WORKING DRAFT OF NEC CODE-MAKING **PANEL 4 MEETING OUTPUT**

Document: National Electrical Code®

Revision Cycle: A2025

Meeting Dates: January 21 - 26, 2024

Figure Informational- Informational Note Figure 690.12(D) Label for Roof-Mounted PV Systems with Rapid Shutdown.

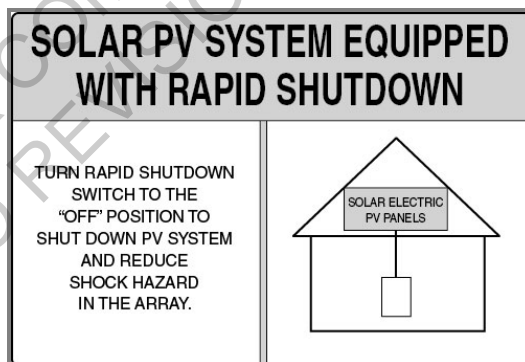
SOLAR PV SYSTEM IS- EQUIPPED WITH RAPID SHUTDOWN.

TURN RAPID SHUTDOWN SWITCH TO THE "OFF" POSITION TO SHUT DOWN

PV SYSTEM AND REDUCE SHOCK HAZARD IN ARRAY.

Committee Statement: The word "is" is removed as unnecessary to communicate this information. This is also consistent with the Figure in the informational note. As written the requirement allows for additional language for tailoring for a specific use.
